RESOLUTION

R33 - 2022

Certificates of Appropriateness for work in the Historic Districts: 304 N. 15th Street, 1011 W. Linden Street, 1502 Chew Street, 106 N. 17th Street, 942 W. Liberty Street, and 405 N. 8th Street

FINAL REVIEW

Item #4e- HDC-2022-00004 Address: 942 W. Liberty Street

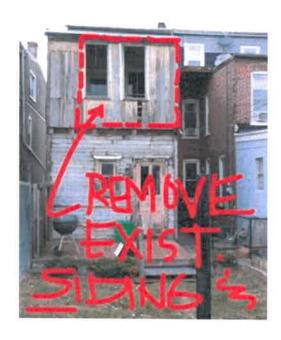
The proposed work at the front porch meets the Guidelines with in-kind replacement of deteriorated wood features to match existing features and limiting replacement to missing or deteriorated components. The application notes that replacement of the porch roof may be required and EPDM black rubber roofing is proposed; if more deterioration is uncovered during repair work and roof replacement becomes necessary, the Applicant should contact Staff about the proposed work and materials. Note that EPDM roofing is generally not recommended (Guidelines, page 15).

At the rear porch, the proposed removal of non-historic siding is appropriate. The use of vinyl railings does not meet the Guidelines. If the two existing wood posts are deteriorated beyond repair, in-kind replacement with new wood turned posts to match the existing is the preferred preservation treatment.

HARB member Glenn Lichtenwalner made a motion to approve with conditions the application dated 01/18/2022 for replacement of deteriorated porch elements including beams and ceilings as well as replacement of existing vertical siding, window frames and deteriorated posts from an enclosed rear porch with vinyl railings and similarly profiled vinyl posts; the front façade scope of

work includes replacement trim, brackets, moldings and related sections for roofing in kind to match the existing

profile and dimension. The conditions presented and agreed to by the applicant include removing the scope of work related to the rear porch from this application to be resubmitted as a separate application when complete and approve the scope of work presented for the front façade and porch as submitted.
